**ADDENDUM NO. 1 TO THE SOUTH  
GROUNDWATER CONTAMINATION PLUME  
REMOVAL ACTION PARTS 2 AND 3 WORK  
PLAN OCTOBER 1993**

**DOE-FN/EPA  
12  
ADDENDUM**

**Fernald Environmental Restoration Management Corporation  
(FERMCO)**

**The United States Department of Energy  
Fernald Site Office**

# Figure 1

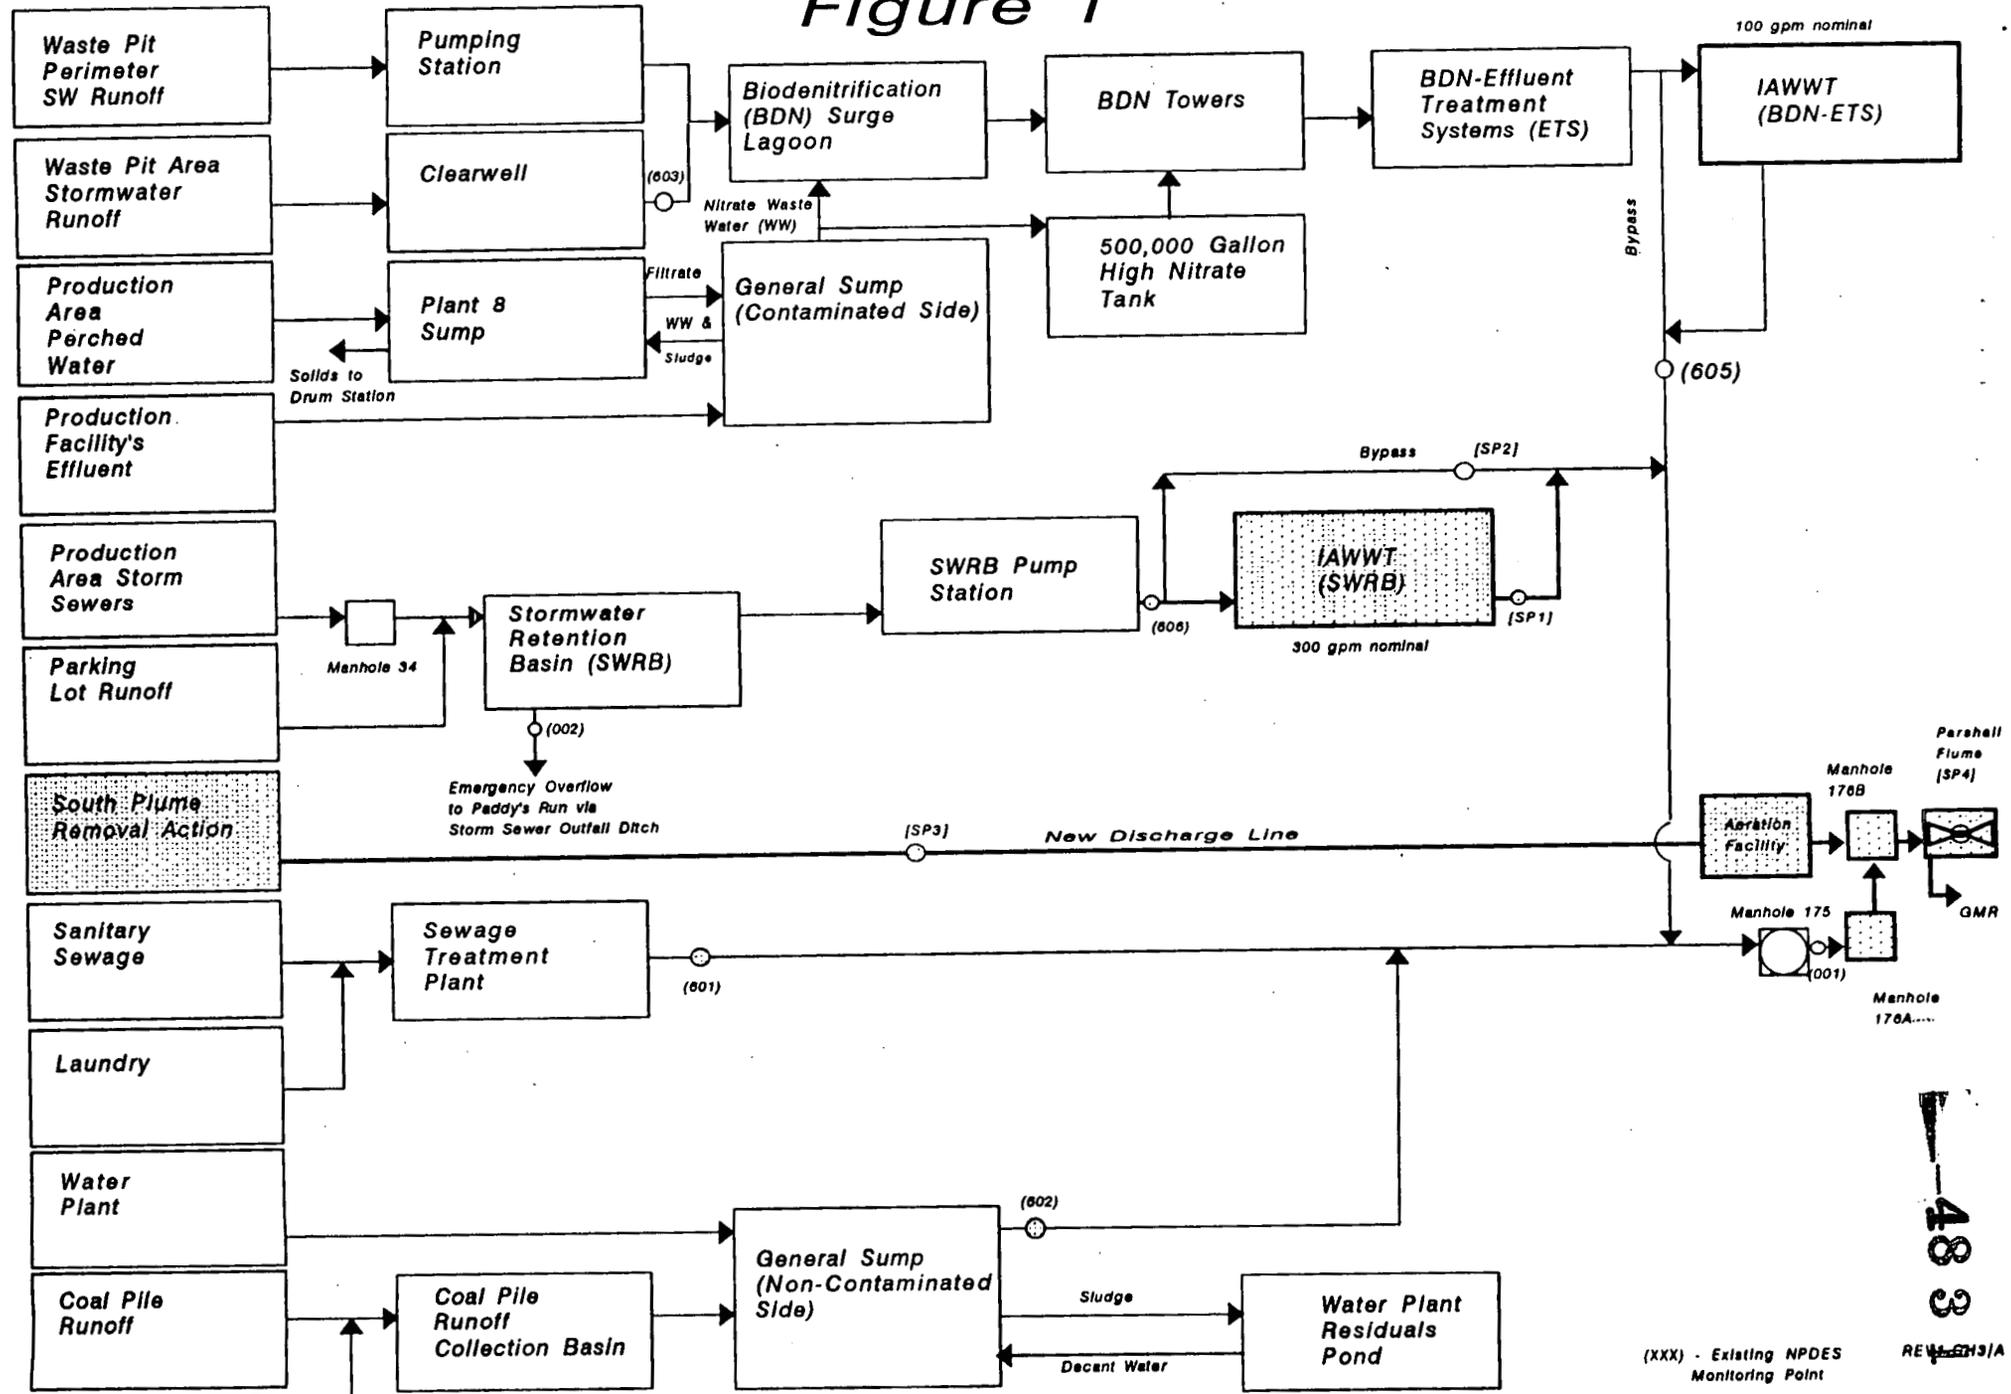
Addition of an enhanced filtration system (see Section 2.4) was made possible because of planned piping modifications to the Storm Sewer Lift Station (SSLS) as part of the Advanced Wastewater Treatment (AWWT) Plant project. These modifications will provide dedicated piping from the SSLS to the General Sump. This piping, when combined with existing piping from the SWRB to the SSLS will be utilized to direct enhanced filtration backwash flows to the General Sump. The IAWWT(SWRB) effluent, which currently utilizes the existing piping from the SWRB to the SSLS will be re-routed to discharge directly to the 24" South Plume discharge line recently installed in Part 2. These piping modifications are reflected in Figures 1, 2, and 3, which show the existing flows and the planned flows once SPIT and AWWT Phases I & II are implemented. Note that planned changes to Water Plant and Laundry flows are shown but not emphasized as they are not key to this project.
